Addendum No. 3

RE: Contract # C205195

Catawba County (I-5716)

INTERCHANGE AT I-40 AND SR-1007 (LENOIR RHYNE BOULEVARD)

Signal Upgrade - Final Design

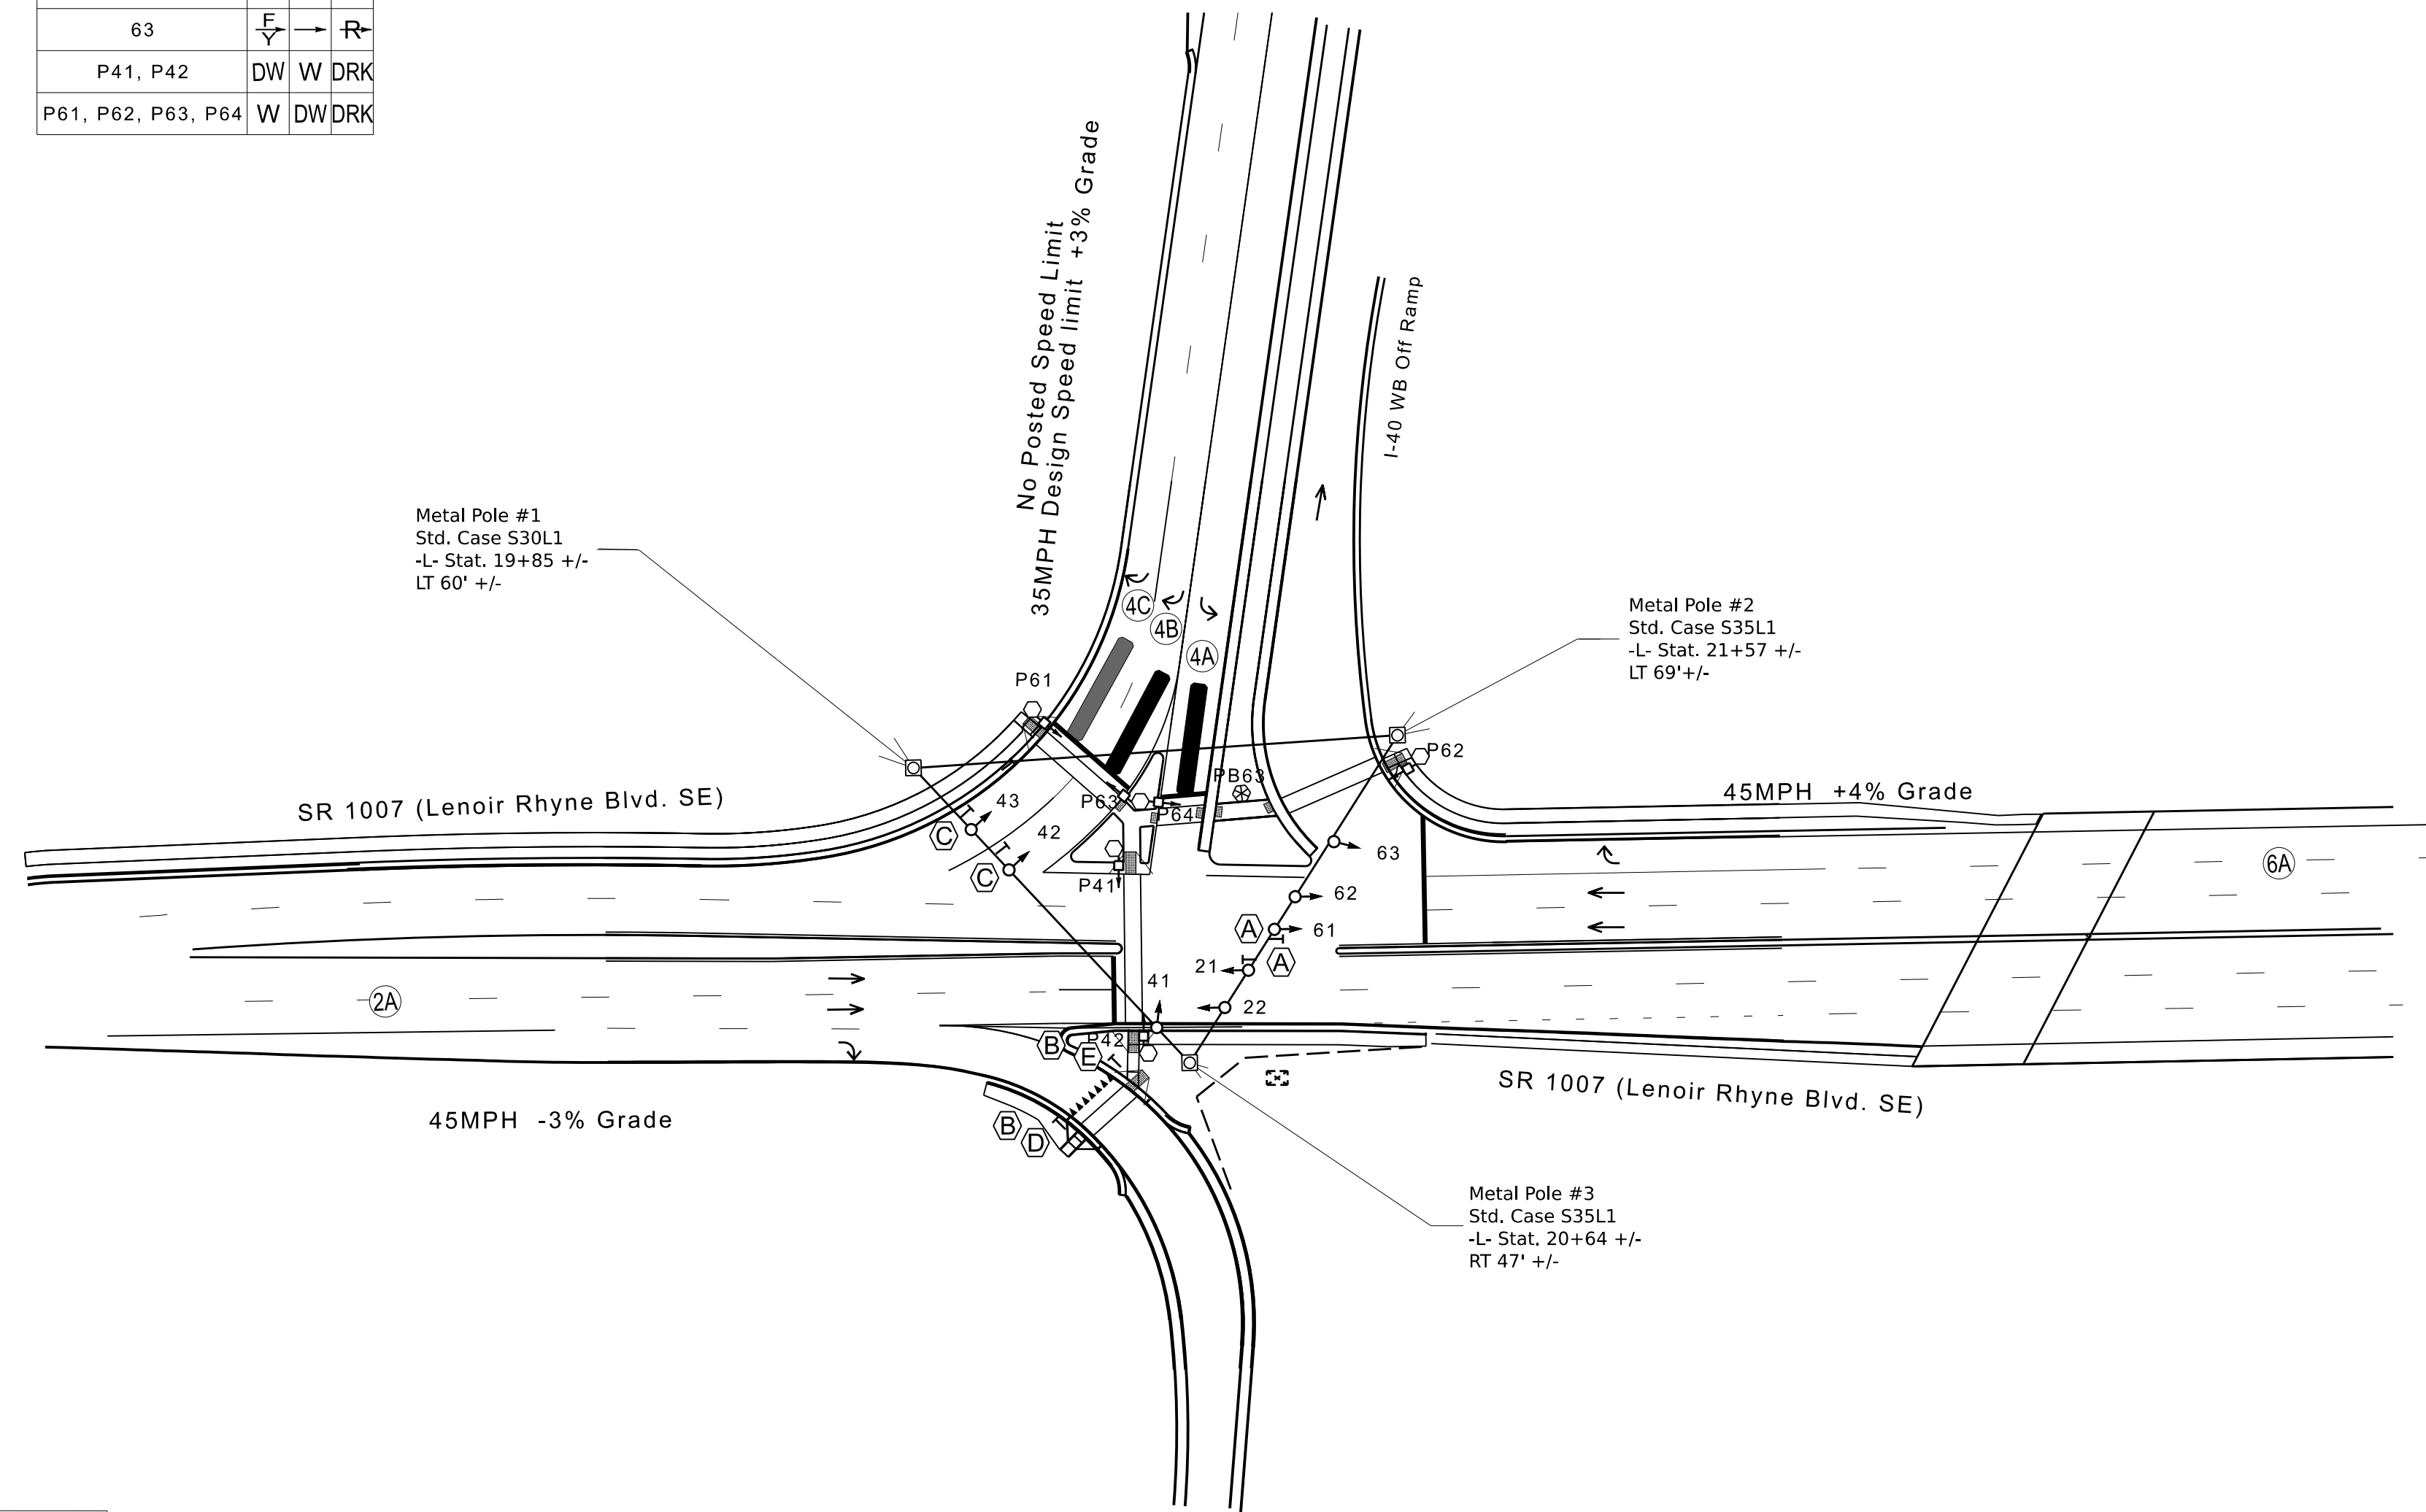
Sheet Nos.	Revision
Sig. 6.0, Sig. 10.0, Sig. 12.0	Revised to include the metal strain pole standard cases.
